Access Compliance Report Public Rights-of-Way (Pedestrian Signals)

Main Street: AIROSO_ST Cross Street: CHIQUITA_CANYON_DR Location: NE

ADA ID: SGRK211130123844 Signal Type: One Push Button-Non APS Overall Compliance: No Severity Scores: BTN 1: 35 BTN 2: N/A No BTN: N/A

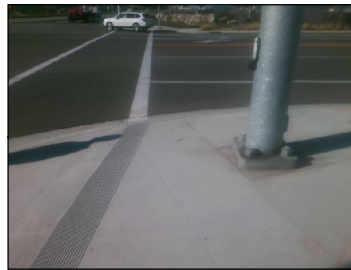
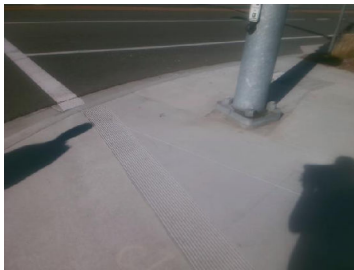
OC Std/PROW: MUTCD 4e.08, R404.2, R404.3

Possible Solutions: Replace Signal Push Button With APS Button. Remove & Relocate Sign.
